# FINAL ROUND 1B TECHNICAL MEMORANDUM

for  
Middle Waterway Problem Area  
of the  
Commencement Bay Nearshore/Tideflats  
Superfund Site  
Tacoma, Washington

prepared for the:  
**Middle Waterway Action Committee**

August 23, 1999

**Figure 3**  
 Middle Waterway Problem Area  
 Round 1A and Selected  
 Historical Sample Stations

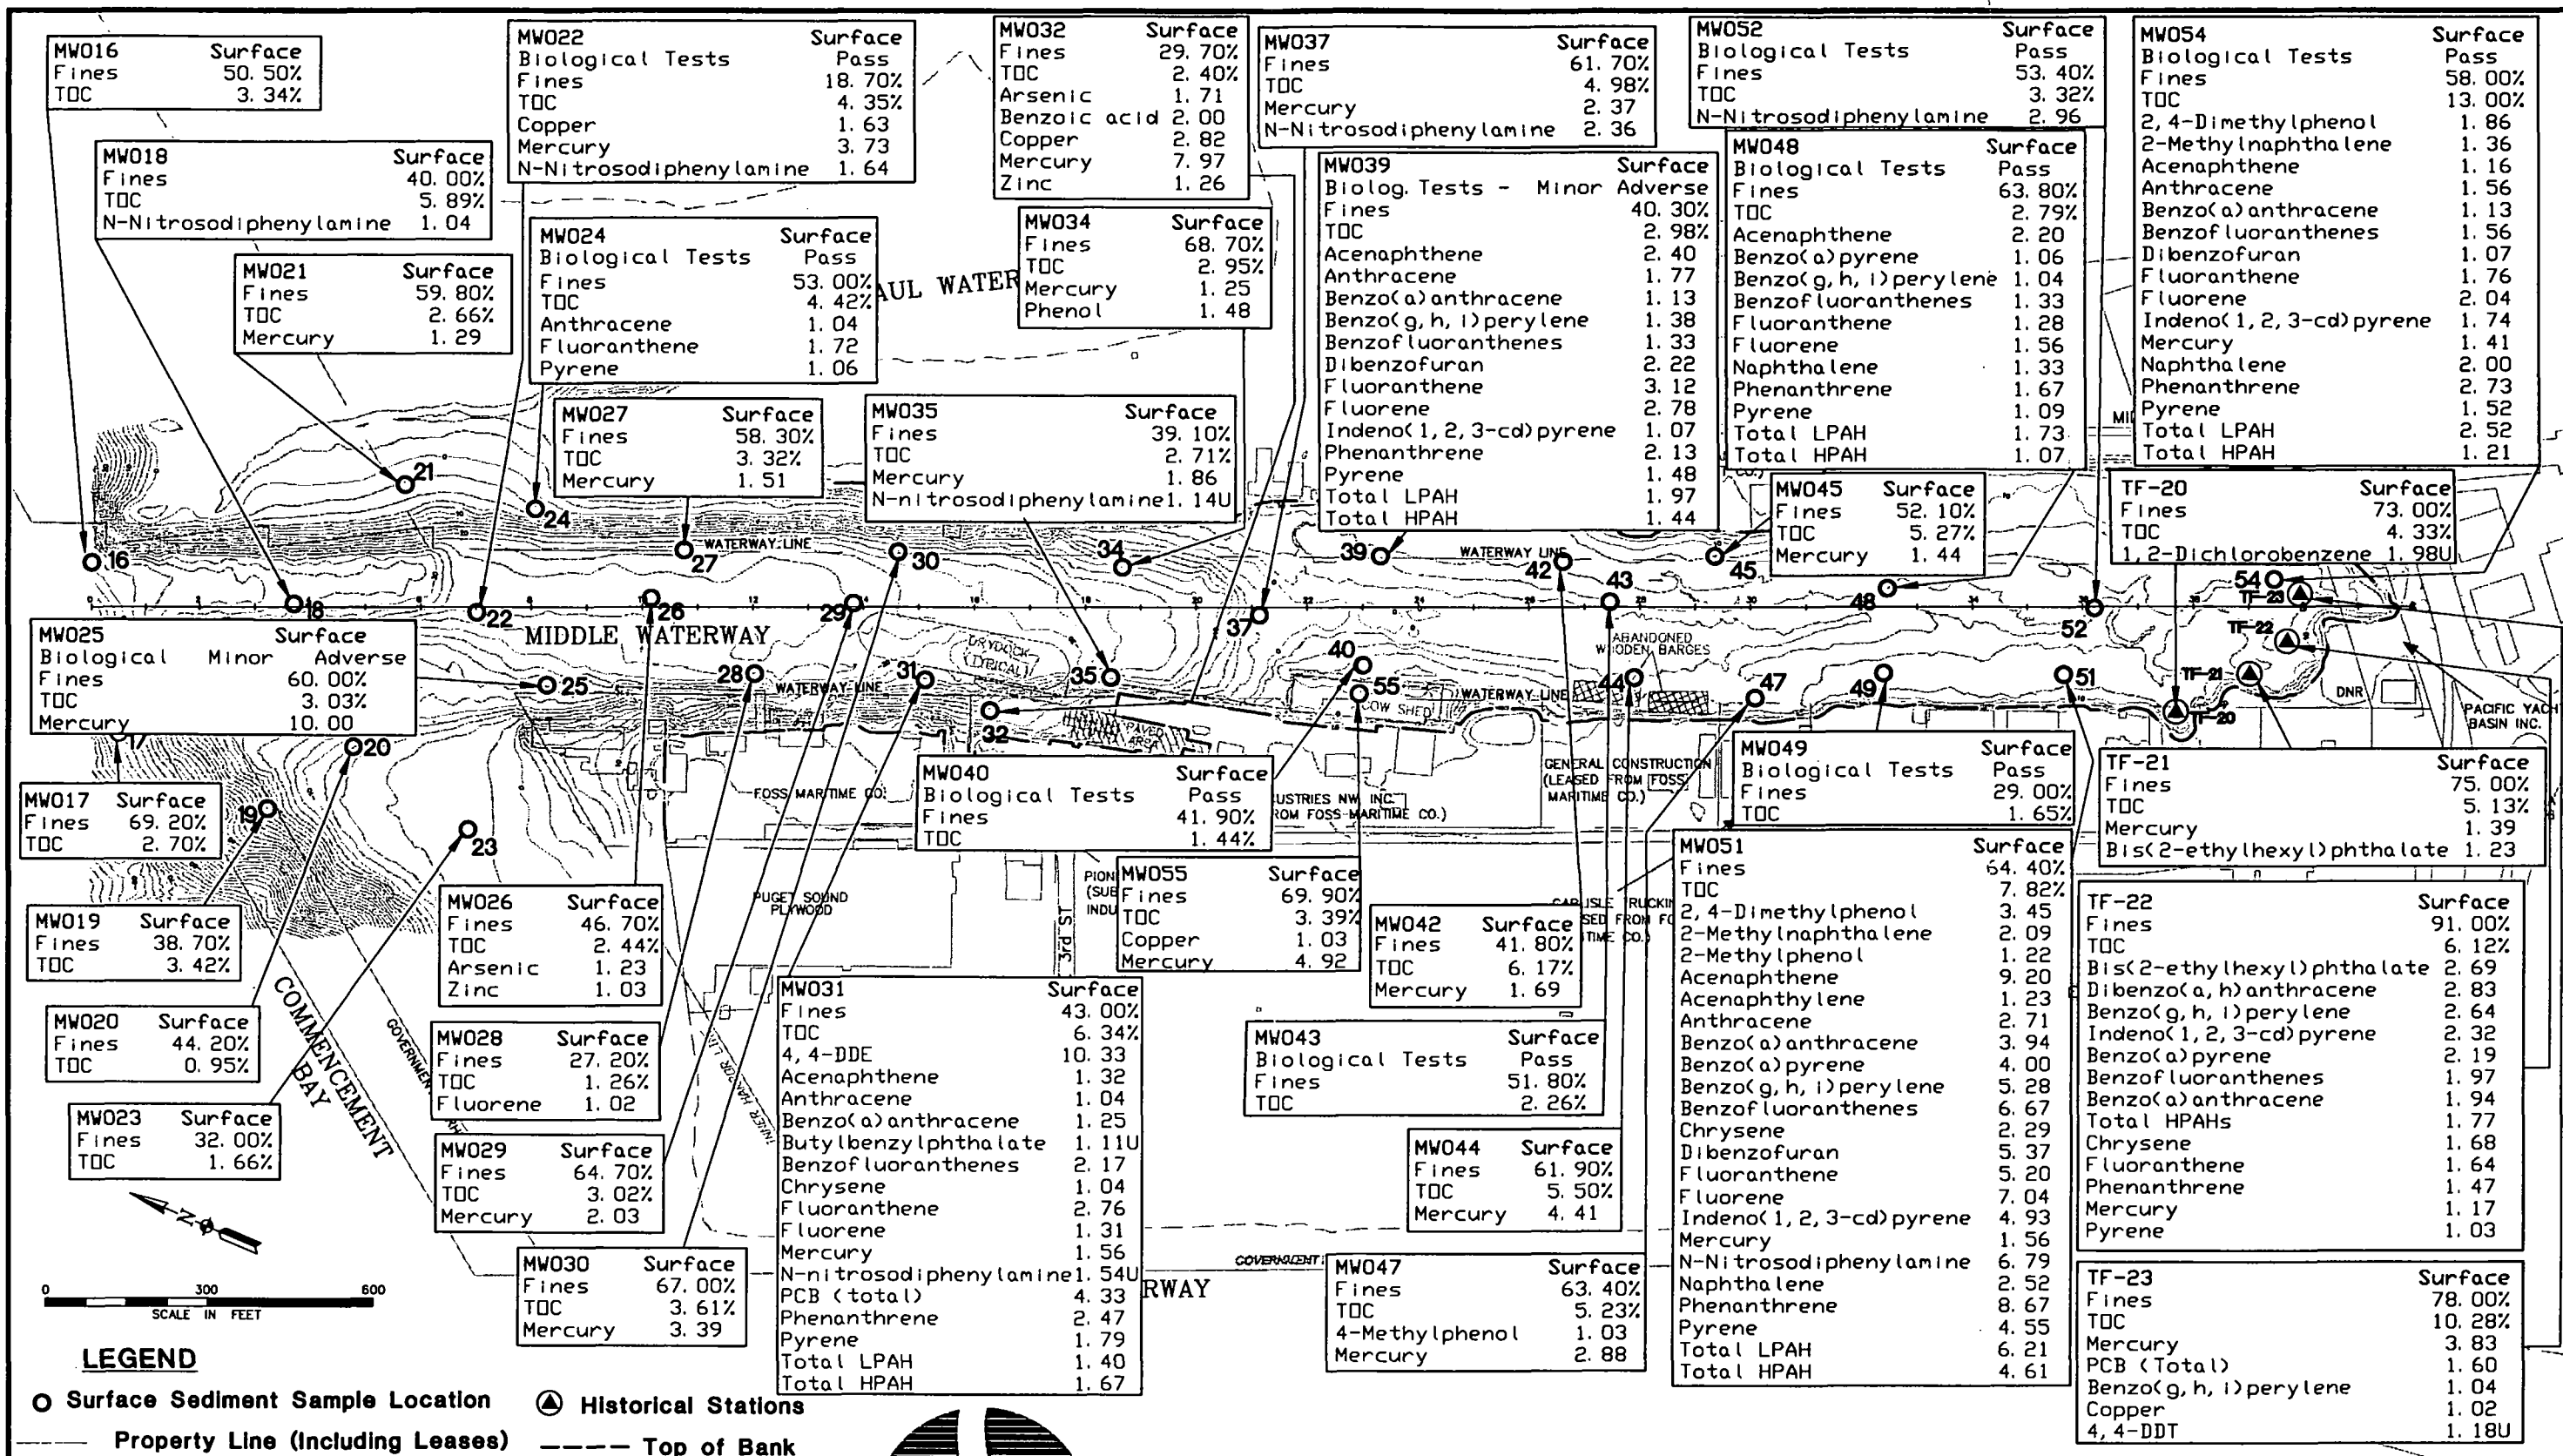
3. **Page 2-2, Section 2.2.1.2, First paragraph.** Fluorene is misspelled in Fig. 3 at MW028.
4. **Page 2-3, First Paragraph.** Based on Figure 3, please confirm that 5 (not 6) benzo(a)anthracene samples, 4 (not 5) benzo(a)anthracene samples, 7 (not 8) fluoranthene samples, 4 (not 5) indeno(1,2,3-cd)pyrene samples, and 1 (not 2) dibenzo(a,h)anthracene samples (no EF is shown for TF-23 in Fig. 3 or Table 2) exceeded the SQO. Benzo(g,h,i)perylene is misspelled in Fig. 3 at TF-23. [Please add definitions for all data qualifiers in Tables 2 and 3, and include those qualifiers in Figs. 3, 4, and 5.]

2. **Page 2.2, Section 2.2.1.1, First Paragraph.** Remove "only" from the phrase "only two samples had exceedence factors greater than 5.0." Based on Figure 3, please confirm that 14 (not 15) of the 21 samples had exceedence factors of less than 3.0.

4. **Page 2-3, First Paragraph.** Based on Figure 3, please confirm that 5 (not 6) benzo(a)anthracene samples, 4 (not 5) benzo(a)anthracene samples, 7 (not 8) fluoranthene samples, 4 (not 5) indeno(1,2,3-cd)pyrene samples, and 1 (not 2) dibenzo(a,h)anthracene samples (no EF is shown for TF-23 in Fig. 3 or Table 2) exceeded the SQO. Benzo(g,h,i)perylene is misspelled in Fig. 3 at TF-23. [Please add definitions for all data qualifiers in Tables 2 and 3, and include those qualifiers in Figs. 3, 4, and 5.]

**Response:** The text has been modified to reflect this comment. The data qualifiers are defined in Tables 2 and 3. Figures 3, 4, and 5 show exceedence factors not concentrations. It is inappropriate to add qualifiers to exceedence factors as they qualify *concentrations*.

**Figure 4**  
Middle Waterway Problem Area  
Round 1A Surface Samples  
And Exceedence Factors

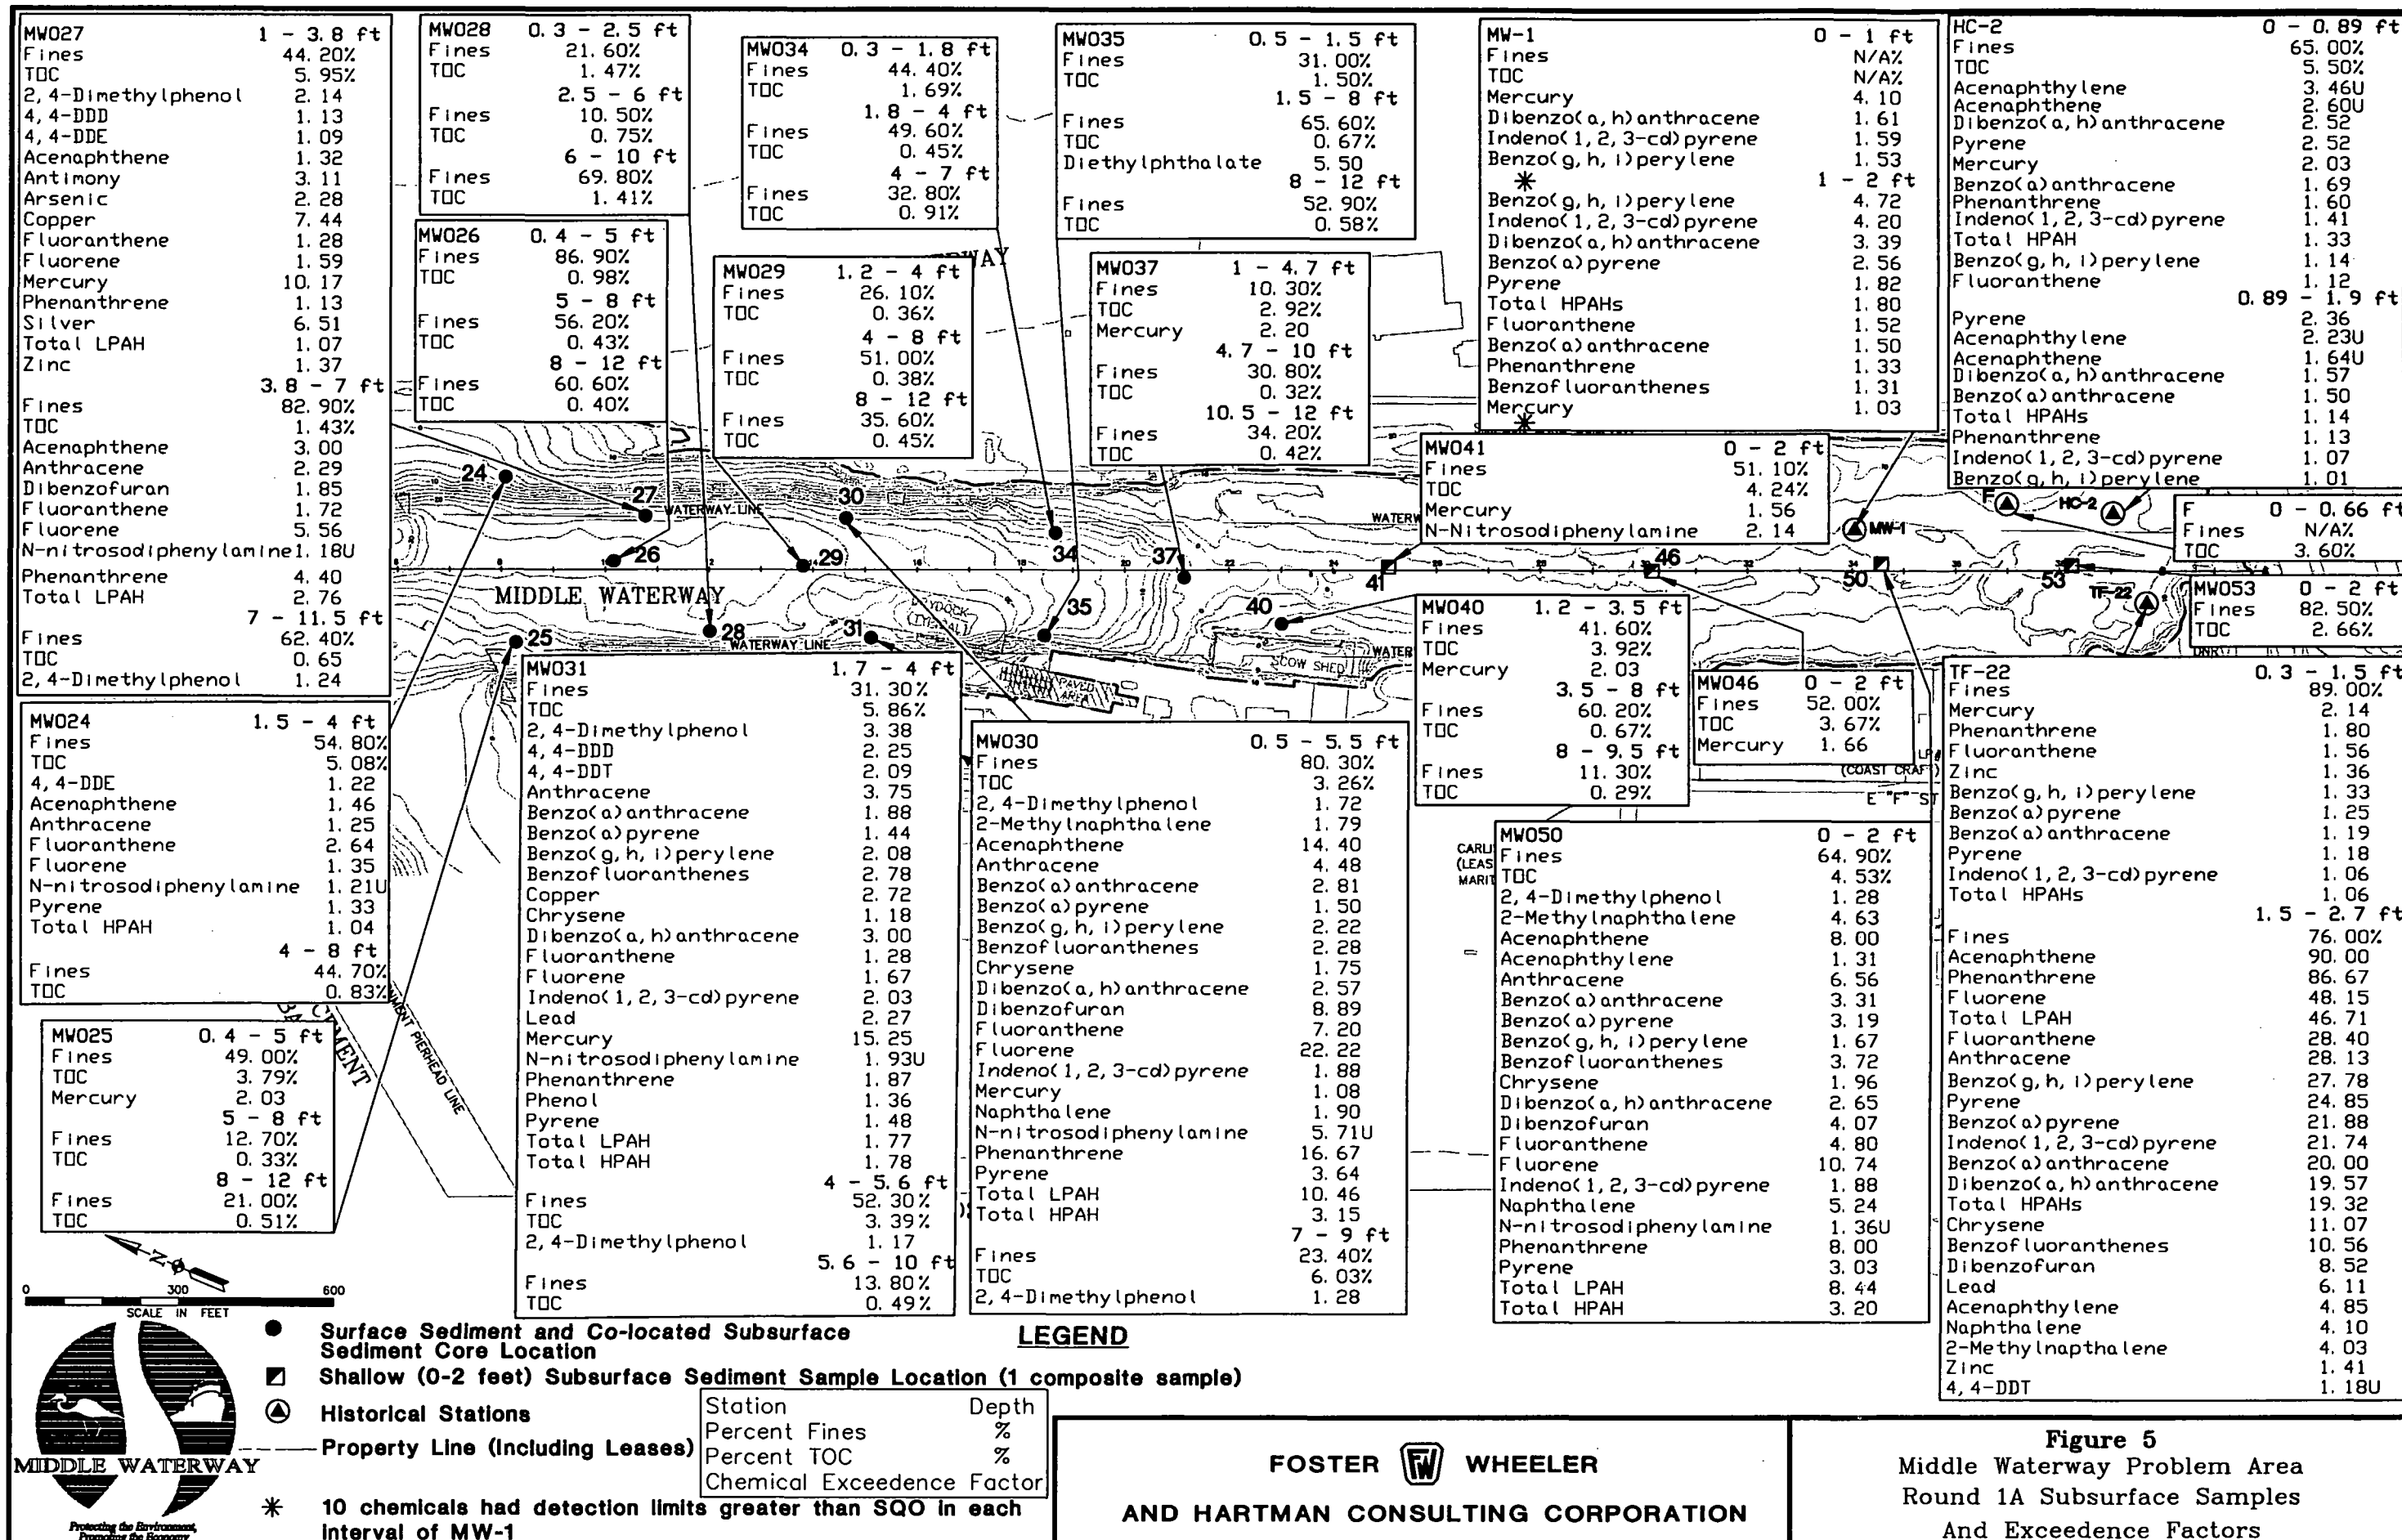
The exceedance factors do not match those shown on Figure 4 in the report. For instance, at MW-24, Table 1 shows an exceedance of 1.08 for Fluoranthene and Figure 4 shows 2.64. Several other discrepancies have also been noted. The samples used for the composite were mostly from the north end of the waterway. Samples from the south end, such as TF-22 have significantly higher PAHs. Its likely that the resultant PAH concentrations may be low.

9. **Page 2-6, First Paragraph.** Based on Figure 4, please confirm that 8 (not 7) benzo(a)anthracene samples exceeded the SQO by a maximum factor of 20.00 at TF-22 in the second interval. Please confirm that dibenzo(a,h)anthracene exceeded the SQO by a factor of 20.00, not 22.00. Please confirm that 10 (not 8) samples exceeded the SQO for fluoranthene. Please confirm that 9 (not 8) samples exceeded the DQOS for pyrene and total HPAHs.

10. **Page 2-7, First Paragraph.** Based on Fig. 4, please confirm that 2,4-dimethylphenol exceeded the SQO at four (not three) stations, including MW050.
11. **Section 2.2.3, First Paragraph.** Please clarify the first sentence so that the 25 samples reported on Fig. 5 can be reconciled with the 21 locations mentioned in the text.

**Response:** The text has been edited to reflect that 16 stations were sampled in the Round 1A sampling event and 4 additional locations that were sampled in 1995 and 1996 are also included on Figure 4. The 5.5 to 7-foot interval from MW030 was not submitted for chemical analysis and therefore there are no results to report on Figure 4. The data from 1995 and 1996 presented in the Tech Memo are treated as part of the data set. The Round 1A sampling event did not re-occupy any of the 1995 or 1996 stations, therefore a discussion of comparability is inappropriate.
